DEVIATION REQUEST AND DECISION FORM

Project Name :	Foundation Lutheran Church	Date: 10/31/2023
Schedule No.(s) :	5225208001	
Legal Description :	TR C PAINT BRUSH HILLS FIL NO 13 A

Figure 2
Site Plan

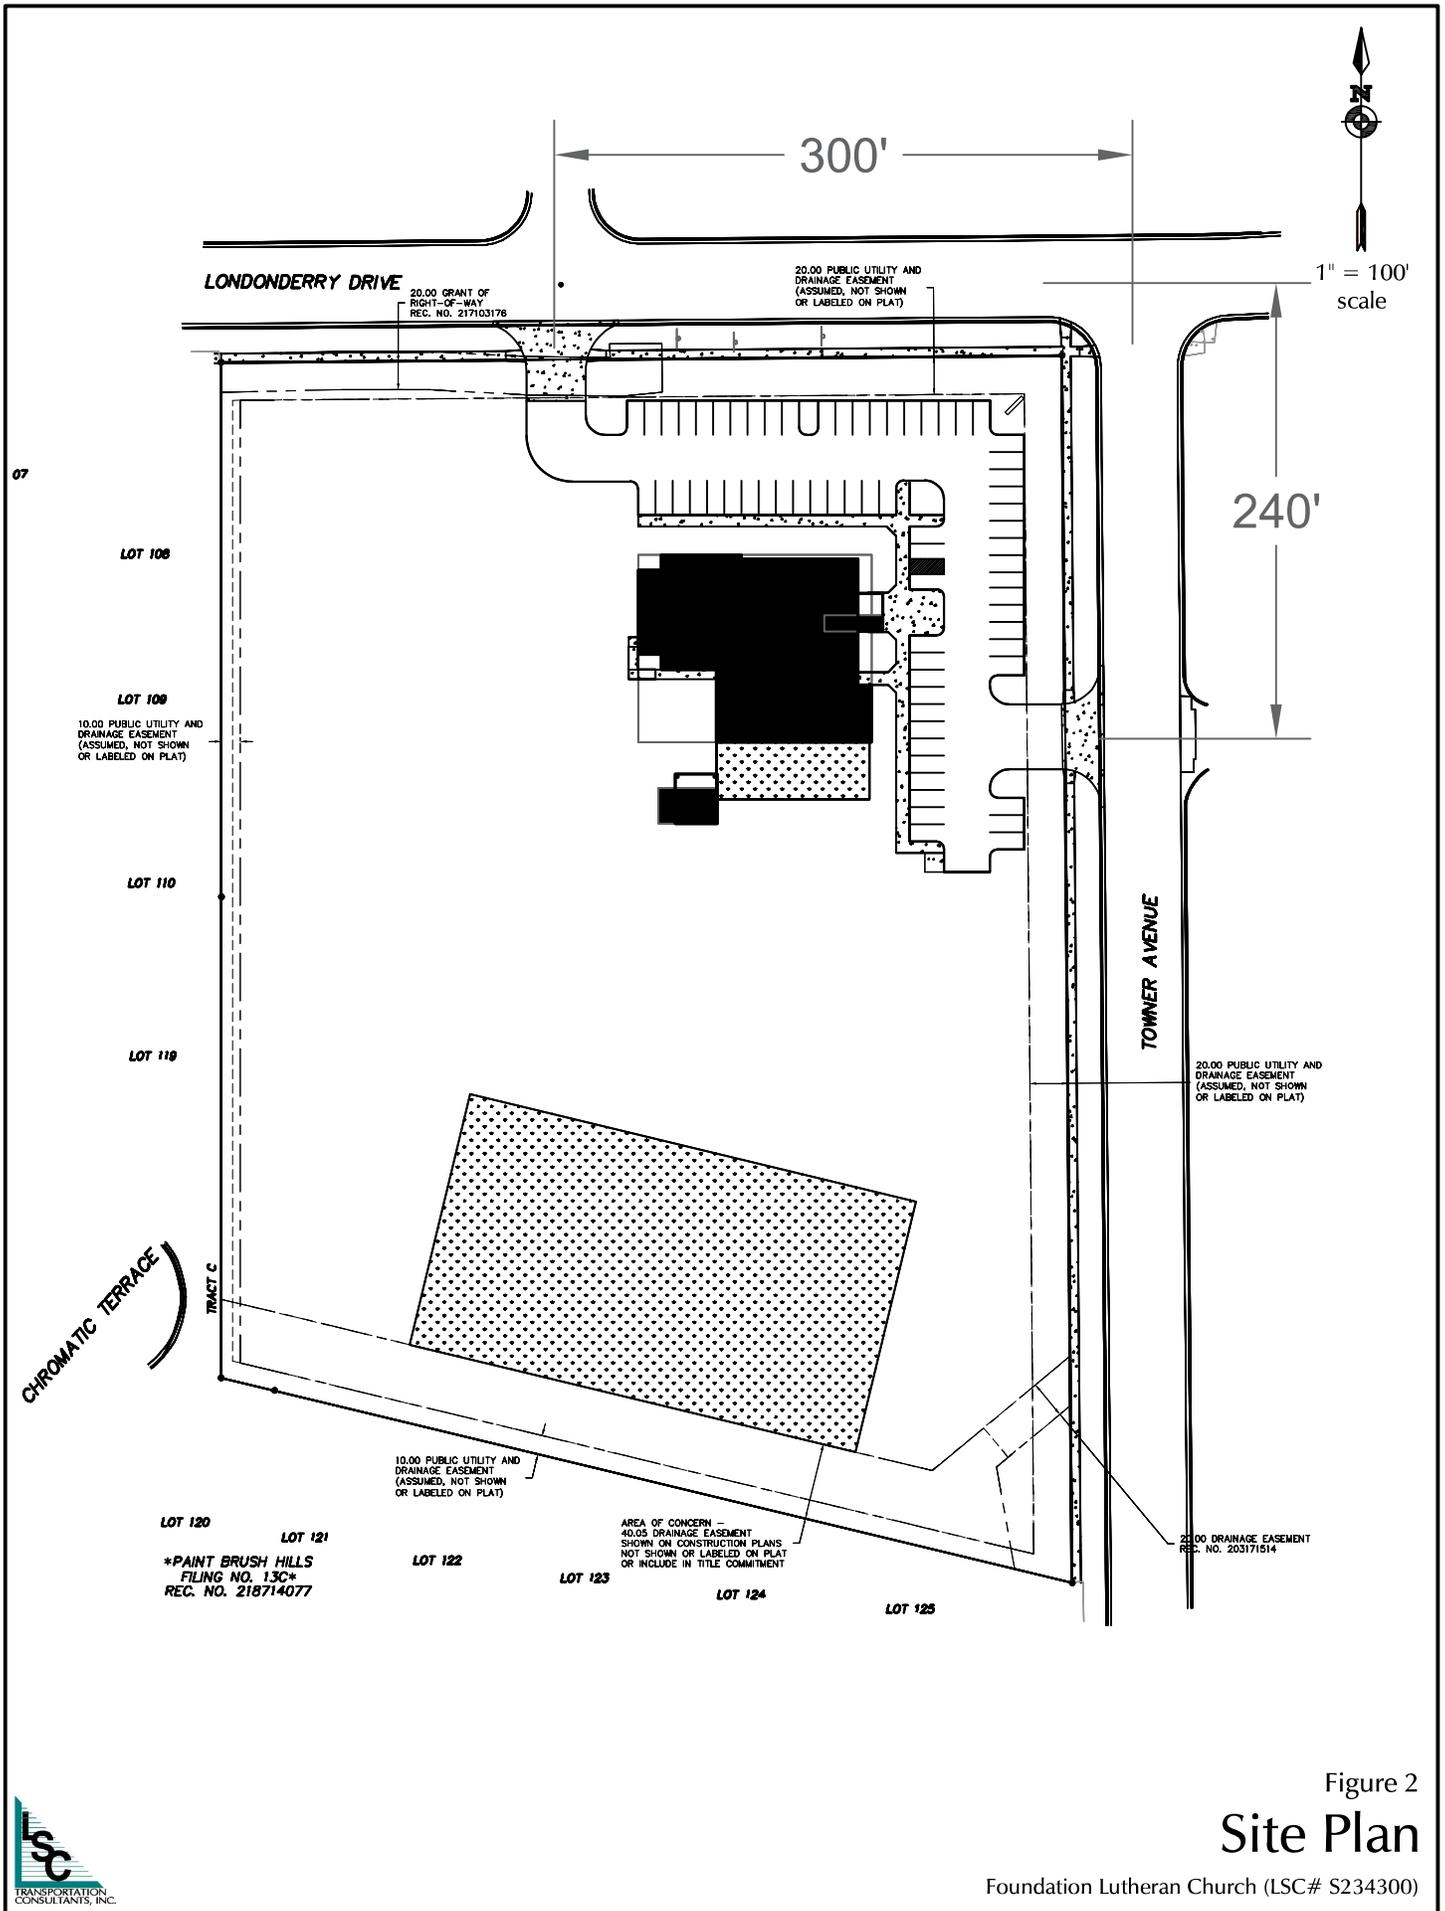
Access to a Collector Street: A deviation from the standards of or in Sections **2.2.5.D** and **2.3.2 (Table 2-7)** of the Engineering Criteria Manual (ECM) is requested. Requests for access are reviewed by the ECM Administrator as per ECM Section 2.2.4.B.4. The request is for the following access points to proposed Urban Non-Residential Collector Streets: Two full-movement access points are proposed – one each to Londonderry Drive and Towner Avenue - both Non-Residential Collector streets. Please refer to the attached copy of Figure 2 of the TIS report.

The request would be for two full-movement access points as shown in the attached figure. Left-turn auxiliary turn lanes would be provided at these access points.

Proposed access to Londonderry Drive and Towner Avenue are consistent with the approved preliminary plan for Paintbrush Hills Phase 2 (PCD File No. SP04006). Left Turn auxiliary lanes at the access points as indicated in the traffic impact study shall be provided.

Figure 9

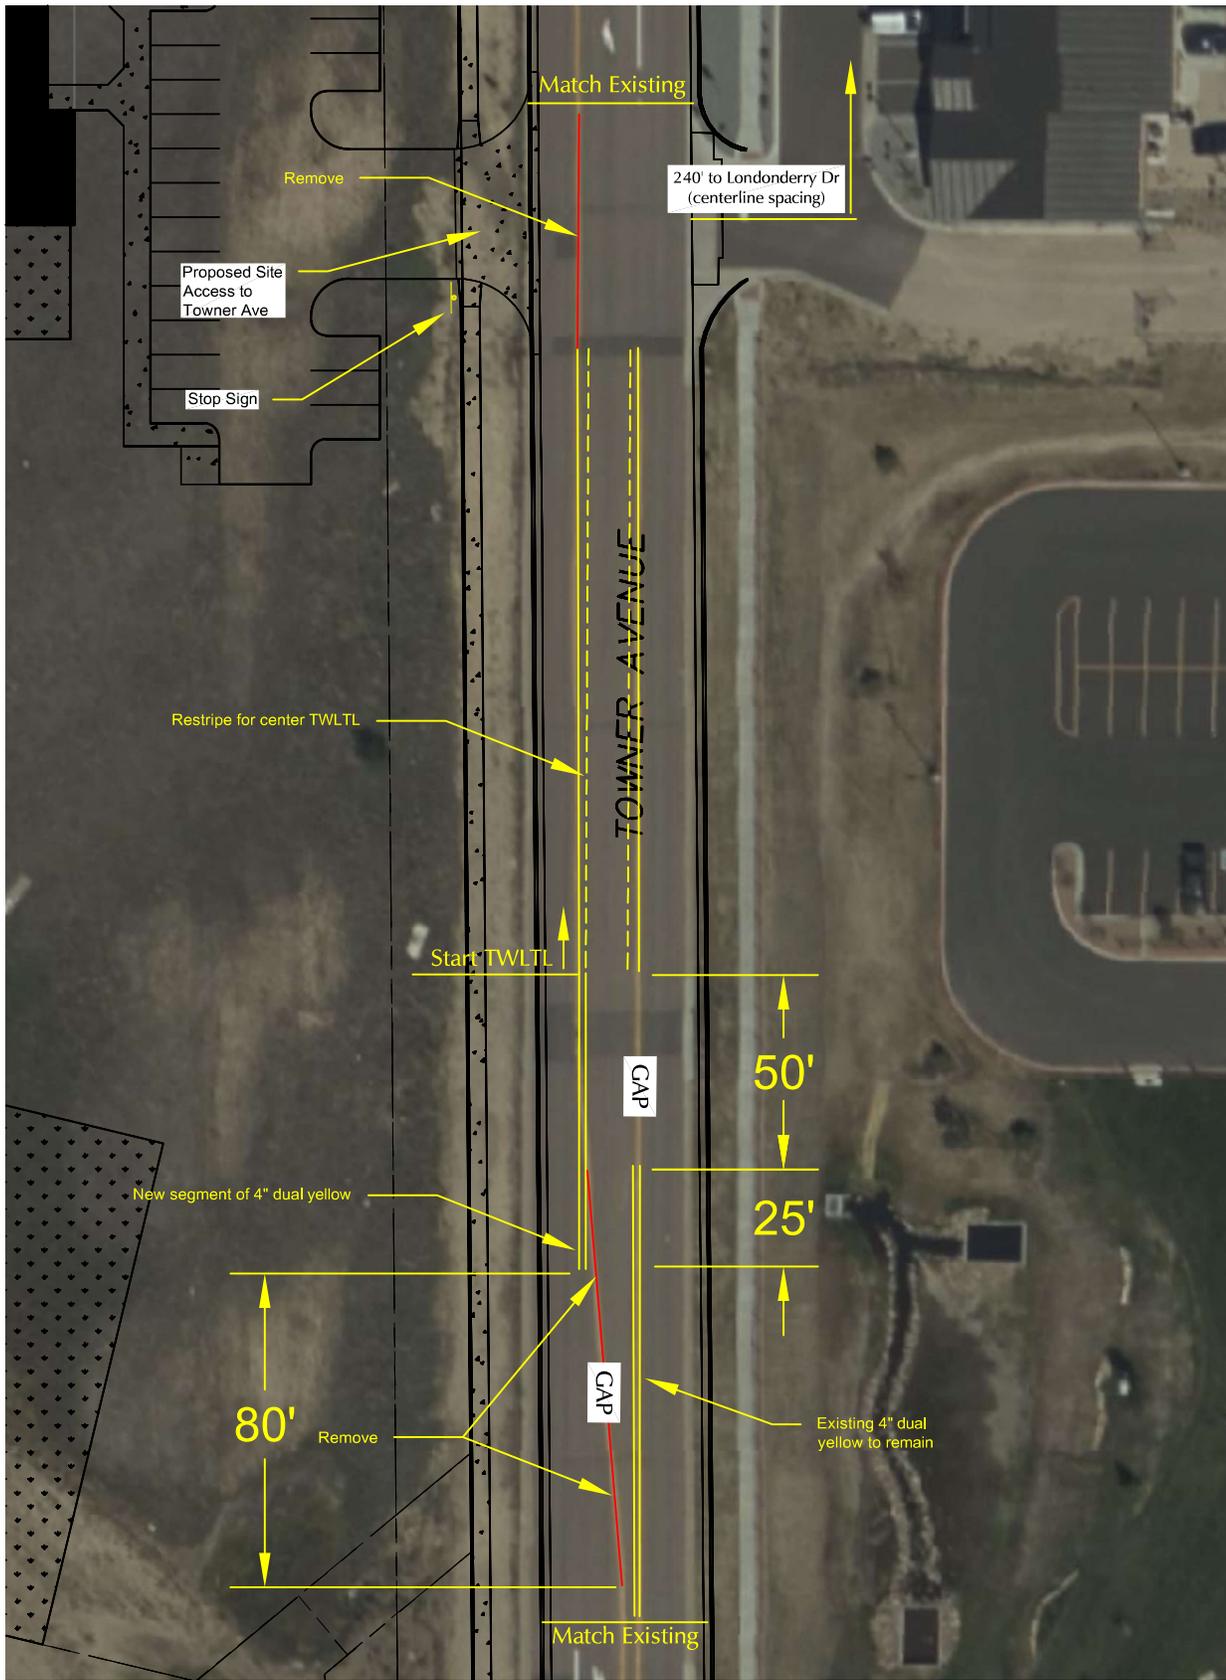
Please refer to the TIS report for sight distance evaluation, level of service analysis and auxiliary turn lane needs analysis. Attached are concepts for restriping for left turn lanes at the proposed access points (taken from the TIS report).
